Comments:

RED - LINE CORRECTIONS

Fig. 3

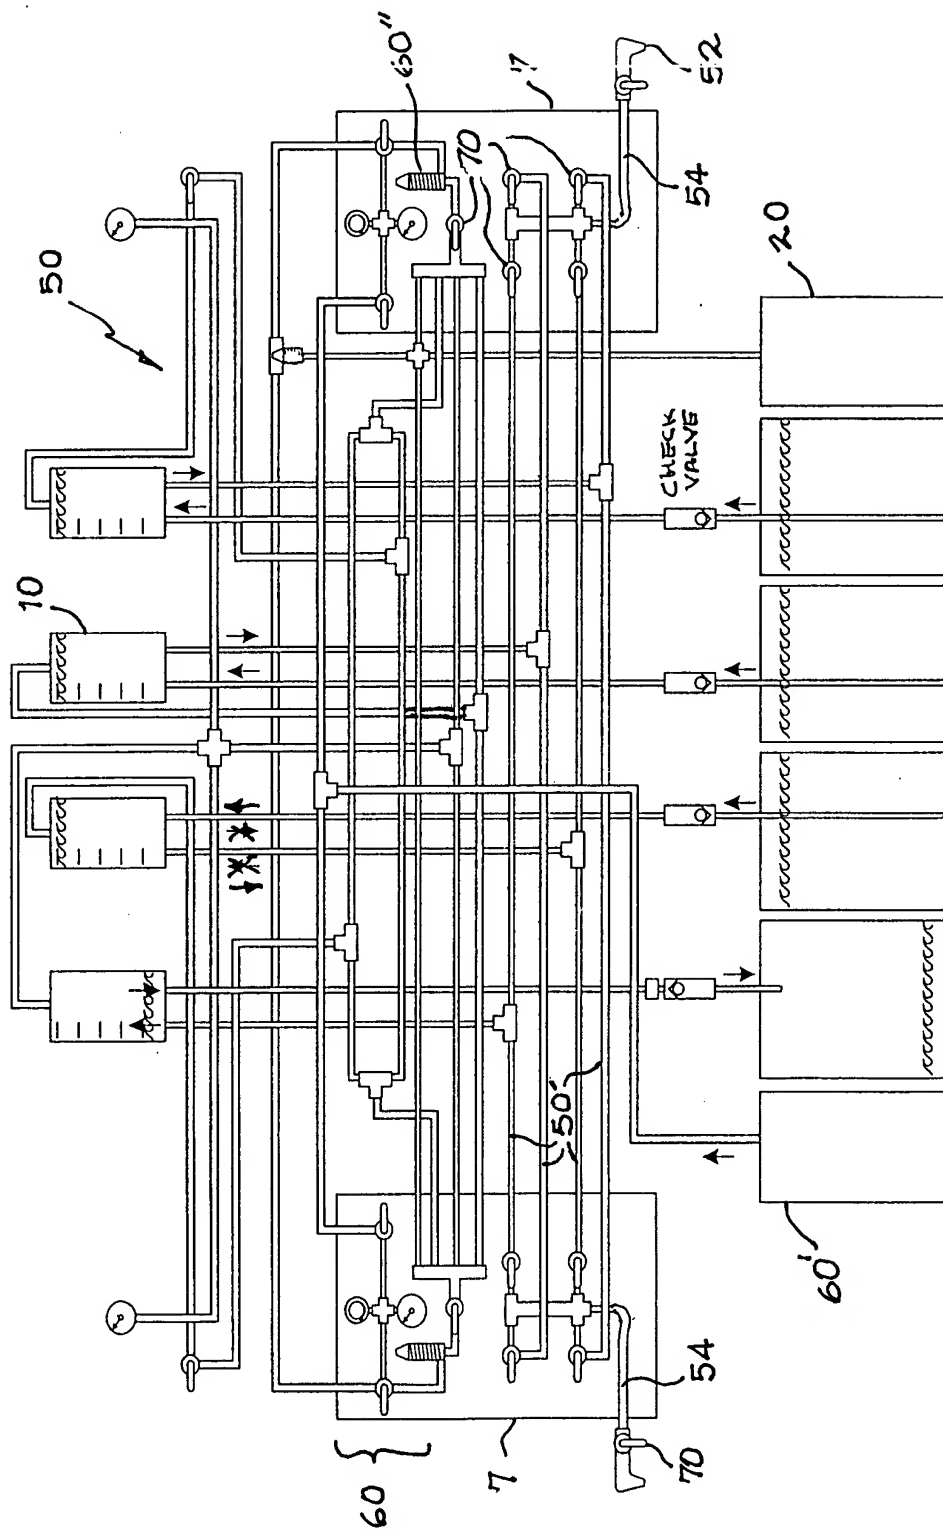
In Fig. 3, there are four tanks (10) shown at the top of the figure. Each of these tanks shows, by arrows, fluid entering on the left and leaving on the right from the bottom of the tank. However, in the second tank from the left the fluid is to enter on the right and leave on the left, and this has been amended in the revised figure 3. This is a drafting error where the arrow senses were inadvertently reversed.

Also, in figure 3, the conduit that extends from the top of the third tank from the left (identified by numeral 10), this conduit terminates shy of its "T" connector which is shown just below the terminal end of this conduit. This has been corrected in this amendment by extending this conduit to connect to the "T" connector, which is shown just below. Again, this is a drafting error where the drafter failed to make connection to the "T" connector.

A replacement sheet showing the corrected figure 3 is enclosed, as well as a red line version showing the corrections. The reference numerals and leader lines have been formalized in all figures.
